HISTORIC AND DESIGN REVIEW COMMISSION

HDRC CASE NO: 2017-655
ADDRESS: 1910 E HOUSTON ST
430 N MONUMENTAL
129 FLORENCE ALLEY
LEGAL DESCRIPTION: NCB 1372 BLK 4 LOT 1&2
NCB 1372 BLK 4 LOT 3 & N 20 FT OF 4
NCB 1372 BLK 4 LOT E 75 OF S 20 OF 4, E 75 OF 5 OR 4B & 5B
ZONING: C-2, RM-4
CITY COUNCIL DIST.: 2
DISTRICT: Dignowity Hill Historic District
APPLICANT: Christopher O'Malley
OWNER: Christopher O'Malley
TYPE OF WORK: Approval of site plan and massing for nine single family, residential units
APPLICATION RECEIVED: December 14, 2017
60-DAY REVIEW: January 30, 2018
REQUEST:

The applicant is requesting conceptual approval for approval of a proposed site plan for nine, single family residential structures.

**Historic and Design Review Commission
 Design Review Committee
 Report & Recommendation**

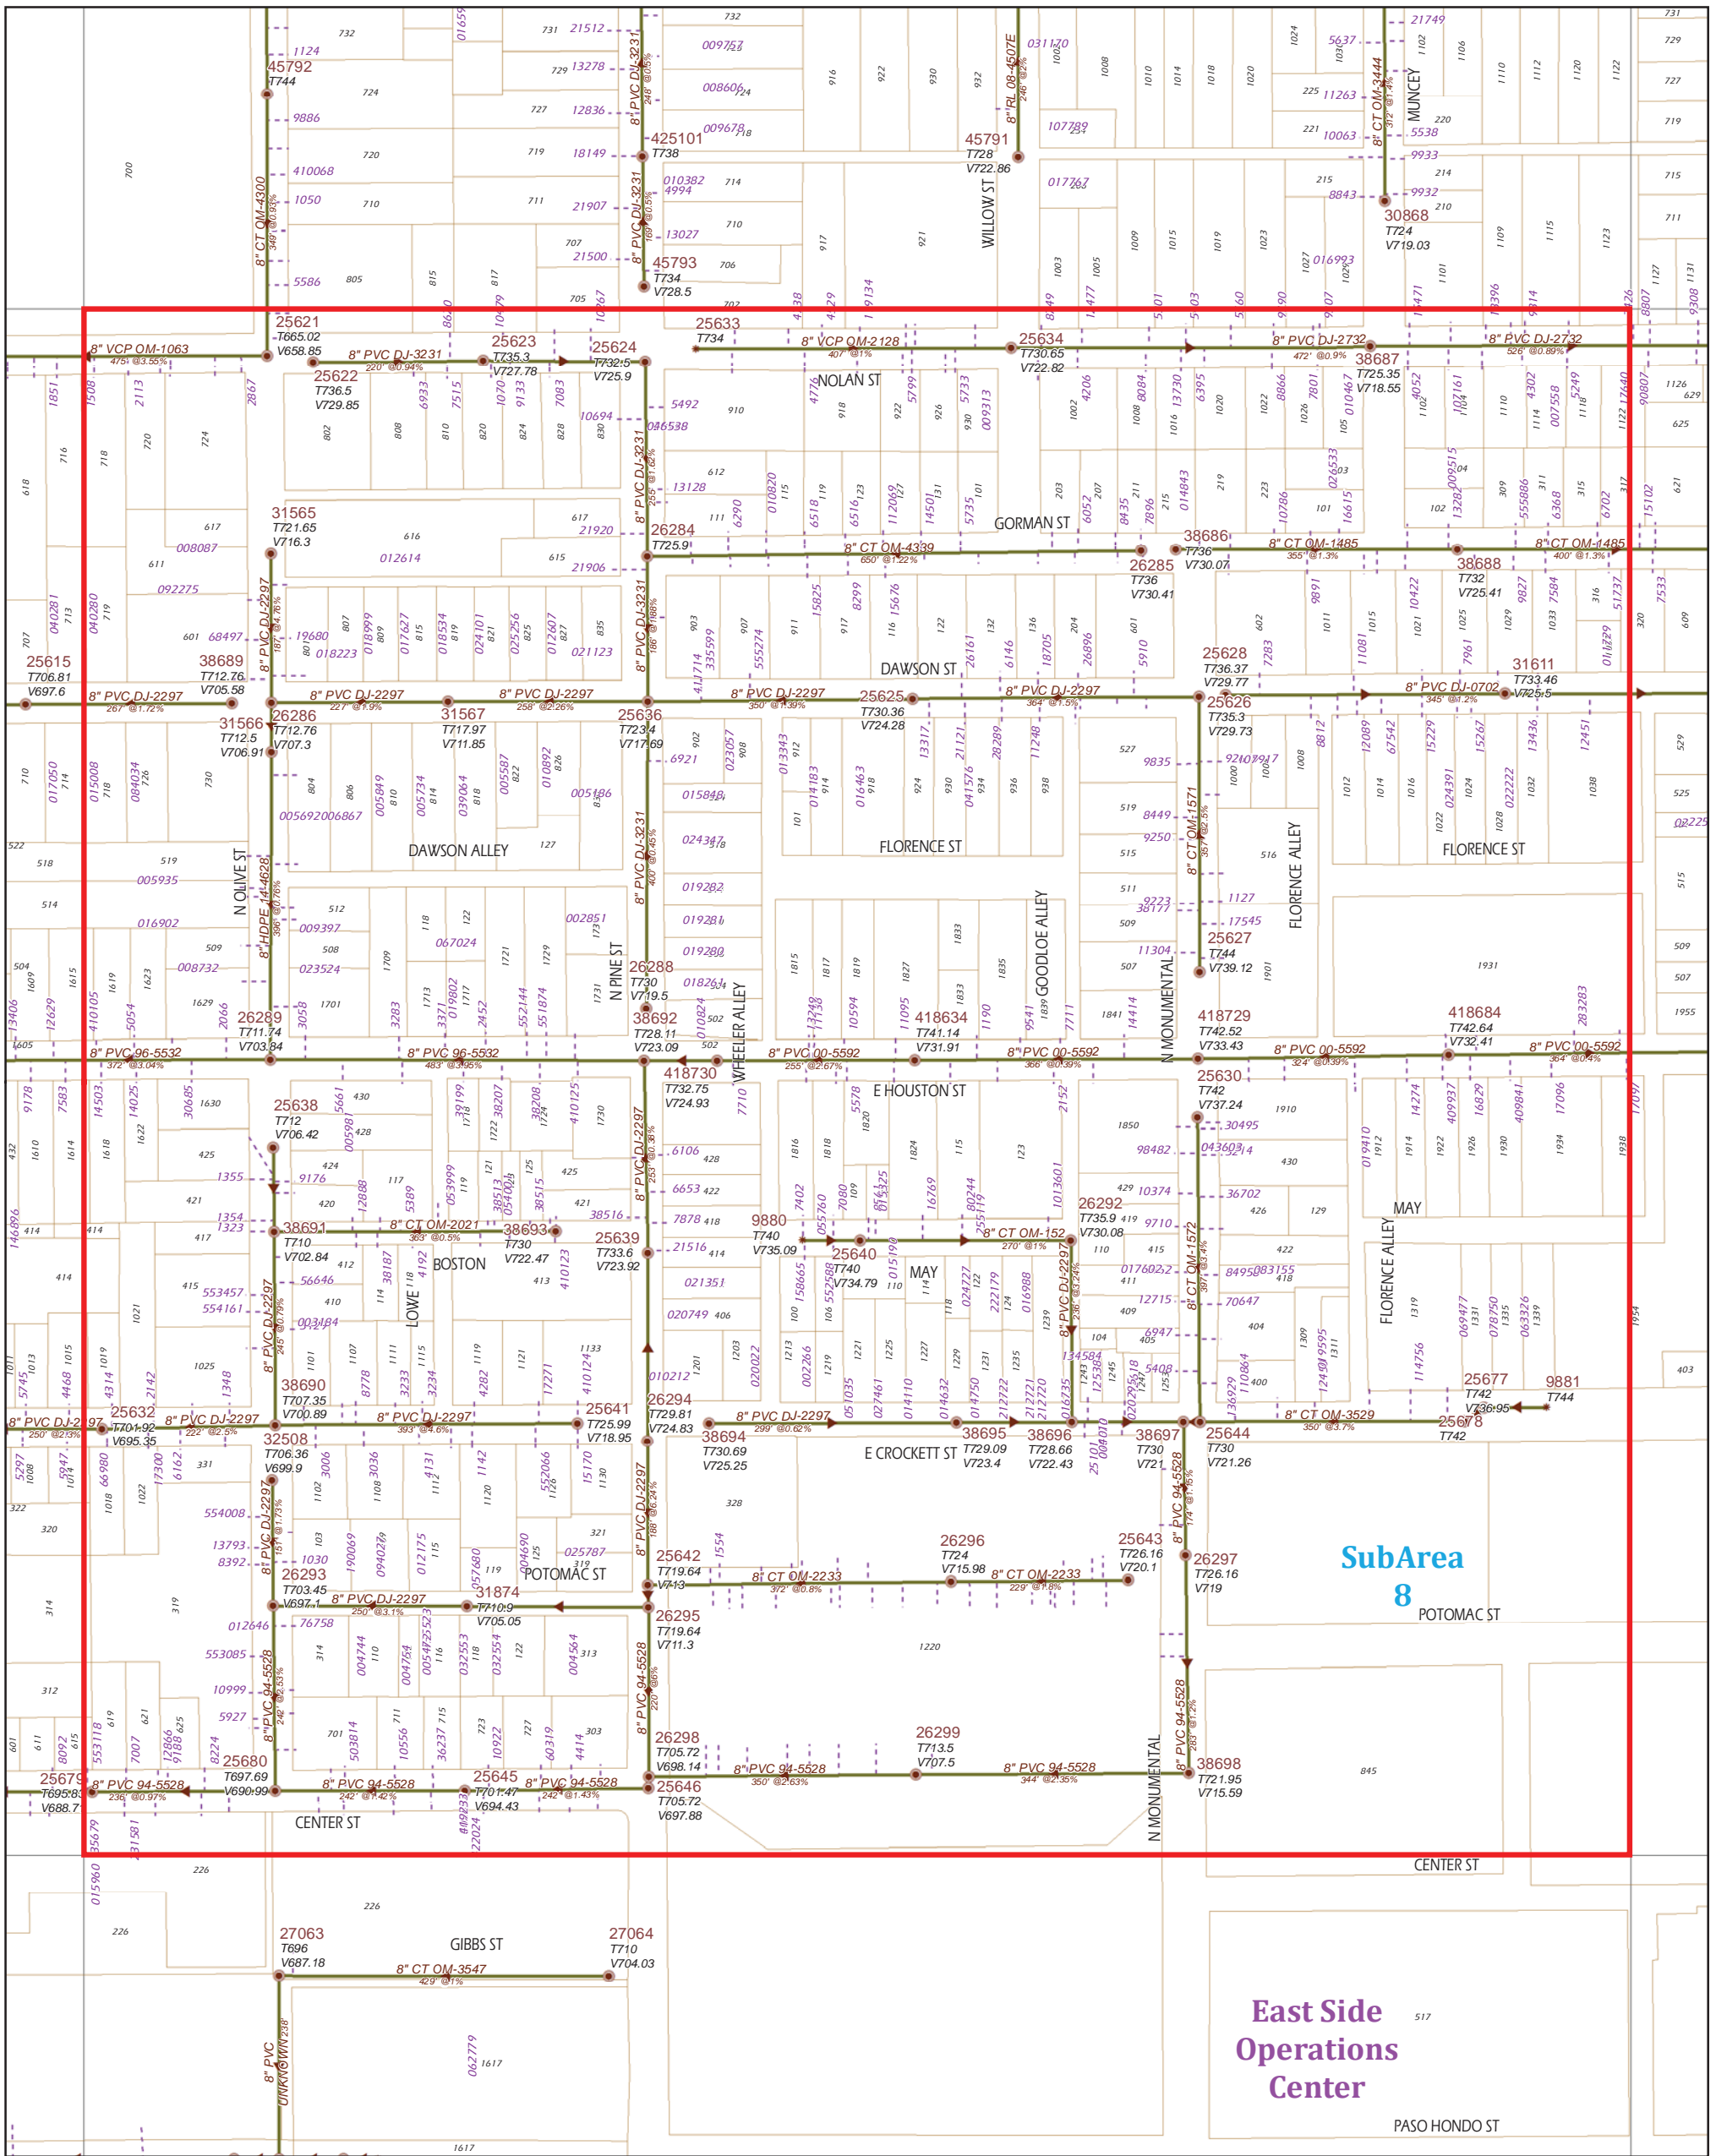
- c. **DESIGN REVIEW COMMITTEE** – This request was reviewed by the Design Review Committee on January 10, 2018. At that meeting, committee members noted that setbacks should be deeper than those of historic structure, that the E Houston street facades should be developed to address the street and noted that the creation of access driveways on Florence and N Monumental may be appropriate.

- e. **SETBACKS & ORIENTATION** – According to the Guidelines for New Construction, the front facades of new buildings are to align with front facades of adjacent buildings where a consistent setback has been established along the street frontage. Additionally, the orientation of new construction should be consistent with the historic examples found on the block. The applicant has proposed for each structure to feature a similar setback to those found historically adjacent to the proposed new construction. Staff finds that the proposed new construction should feature setbacks that are deeper than those found adjacent historically.

- g. **BUILDING WIDTHS** – The applicant has proposed narrow façade widths for structures fronting N Monumental and Florence Alley. For the two structures that are proposed to front E Houston, the applicant has proposed architectural elements to address the width fronting E Houston. Staff finds this to be appropriate.

- k. **DRIVEWAY LOCATION** – The applicant has proposed for the driveways to have access to E Houston, N Monumental and Florence Alley. Each driveway generally presents itself in a manner similar to those found historically in the district. Staff finds this to be appropriate.

COMMENTS/CONCERNS: SD: OVERVIEW OF PROPOSED LOT LAYOUT; EXPLANATION
OF PROPOSED DRIVE. LF: QUESTIONS REGARDING ORIENTATION - ADDRESSING
E HOUSTON - THE PATTERN OF DEVELOPMENT ON E HOUSTON SHOULD BE
ADDRESSED. AMG: FRONT ELEVATIONS / E HOUSTON ELEVATIONS SHOULD
BE DEVELOPED TO ADDRESS SETBACKS. LF: HOUSES
PROPOSED NEED TO FEATURE A SETBACK THAT IS LESS THAN HISTORIC
HOUSE SETBACKS. AMG: DESIGN DOCUMENTS SHOULD BE EXPANDED TO
ADDRESS CONTEXT IN THE VICINITY [SETBACKS ON N MONUMENTAL + E
HOUSTON].

LF! QUESTIONS REGARDING DRIVEWAY PATTERN IN VICINITY, SHOW EXAMPLES OF WHAT EXISTS.

LF! QUESTIONS REGARDING OTHER DRIVEWAY OPTIONS, CONSIDER CREATING AN ACCESS "DRIVEWAY" TO CONNECT ~~TO~~ TO E HOUSTON DRIVE TO POTENTIAL NEW DRIVE ON MONUMENTAL.

Staff recommends conceptual approval of the proposed site plan based on findings a through l with the following stipulations:

- i. That the setbacks of the proposed new construction be greater than those found historically adjacent to the proposed new construction.
- ii. That all mechanical equipment be screened from view at the public right of way.
- iii. That a detailed landscaping plan be developed and submitted at the time of final approval.
